BCA + ACCESS COMPLIANCE ASSESSMENT REPORT

PROJECT:	8-28 The Corso, Manly
REF. No.:	NEW231103
DATE:	18/11/2023
CLIENT:	London Fashions Pty Ltd
CONTACT:	Con Nicola
EMAIL:	con@henroth.com.au
CONSULTANT:	Mauricio Vera
PHONE No:	0451 078 790
EMAIL	mvera@newcrown.com.au

BCA + Access Design Compliance Review

RE: 8-28 The Corso, Manly – Alterations and addition to Shops 4-7

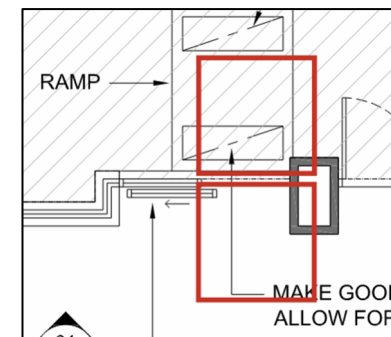
From the information provided, the proposed flooring will be level, flush with abutment surfaces, without drainage strips, and slip resistant.

Test reports demonstrating slip resistance of all different flooring will be required prior to construction.

6. Path of Travel – Ramps (NCC D4D4, D4D12 & AS1428.1)

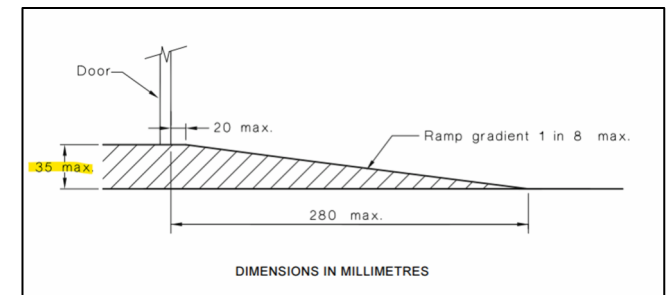
Currently it is unclear if an entry ramp would be necessary. It is expected that if new flooring cannot be level to existing RL's outside Shop 4-6, a threshold ramp may suffice (up to 35mm level difference), in compliance with AS1428.1 CI 10.

10. Glazing (NCC D4D13 & AS1428.1)

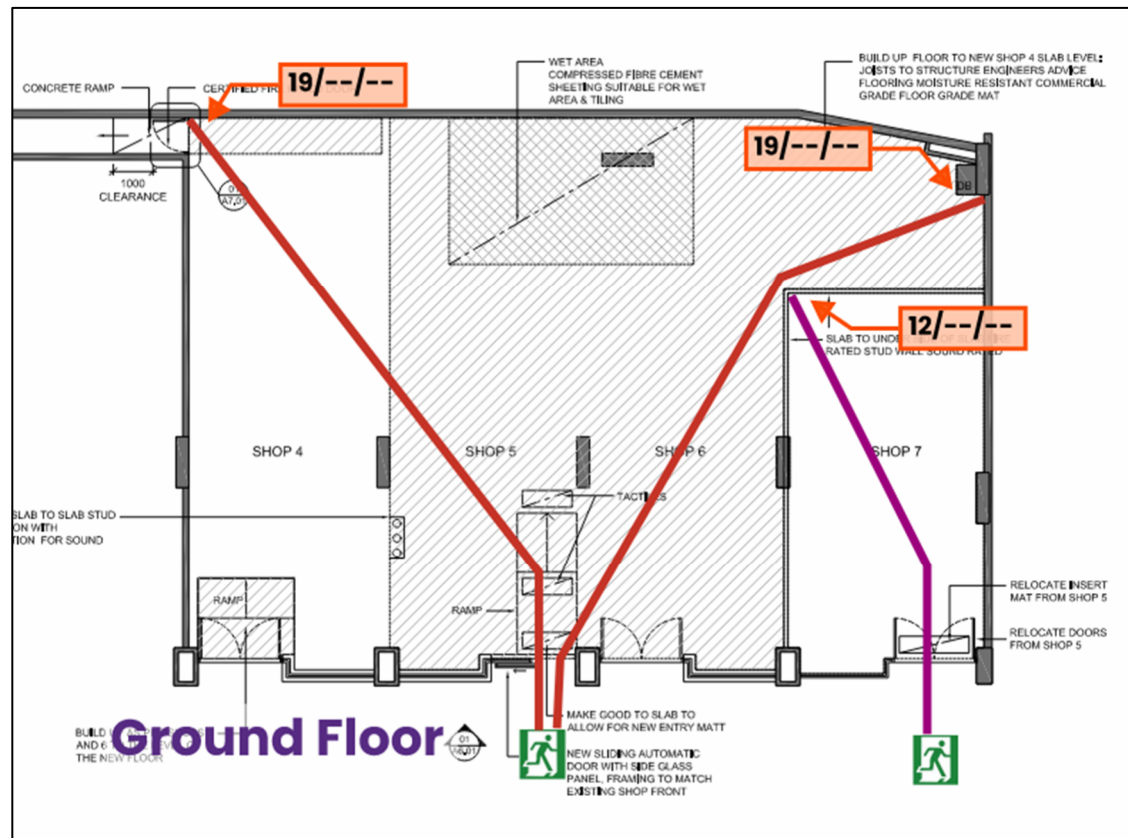
Decal strips are to be provided at the front glass façade.
